# **Record of Decision**

## **U.S. Highway 93 Ninepipe/Ronan Improvement Project**

## **Final Supplemental Environmental Impact Statement and Final Section 4(f) Evaluation**

Ten comments on the final SEIS were received from the general public and reviewing agencies during the public review period. The comments and responses follow.

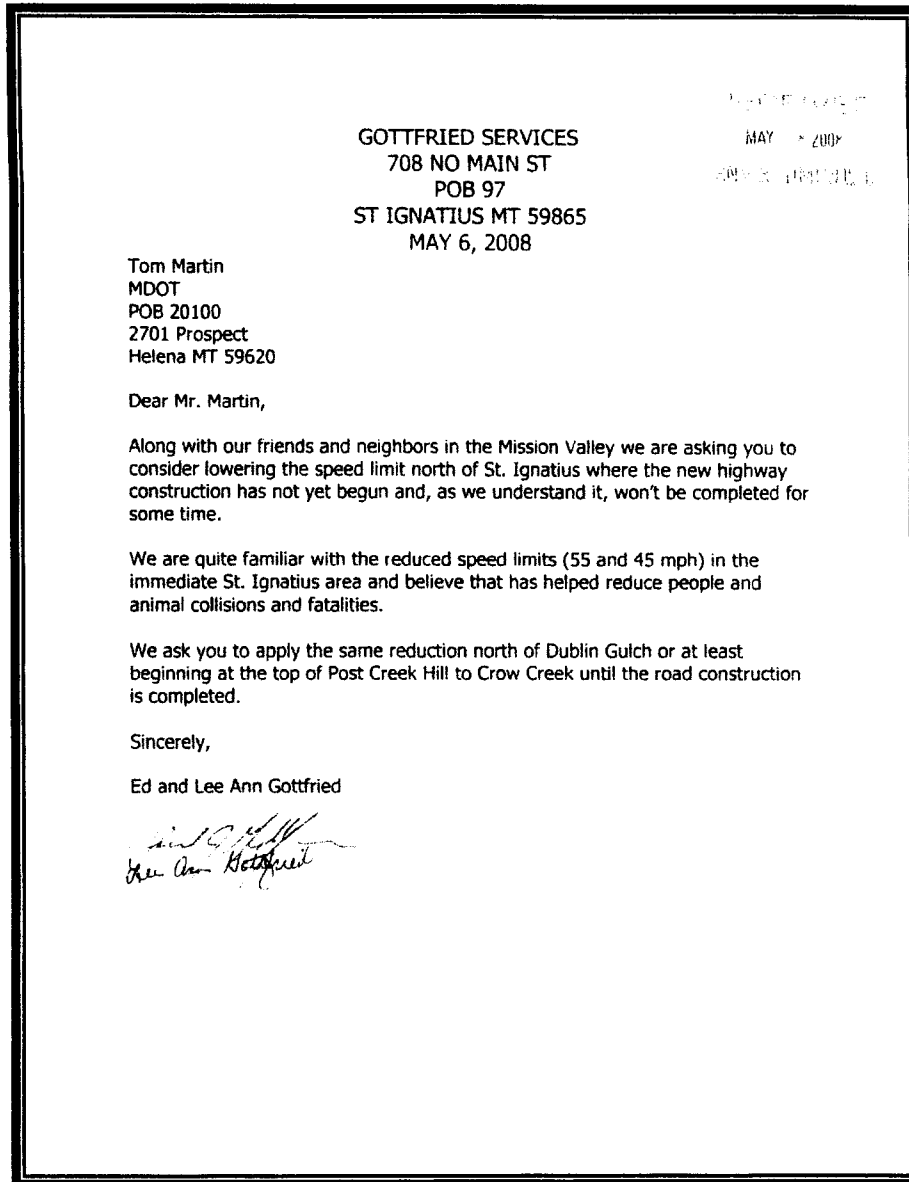
4.2 I THOUGH ORIGINAL PLAN WAS TO TAKE EQUAL AMOUNT OF LAND FROM BOTH SIDES.

4.3 WITH PASSING LANE GOING PAST MY PLACE IT WILL BE DIFFICULT TO GET ONTO HIGHWAY IN THE WINTER, GOING DOWN OR APPROACH I SLOW PAVED FROM 2 LANE.

It is unfortunate you were not previously aware of the plan to require more property from the east side of the road. The Draft Supplemental Environmental Impact Statement (draft SEIS) dated August 6, 2006, was circulated during August, September, and October of 2006 and contained the same roadway alignment and feature for requiring more right-of-way from the east side as is shown in the final SEIS. Also, there were two open houses, one in St. Ignatius and one in Ronan where large size maps were exhibited showing these same features.
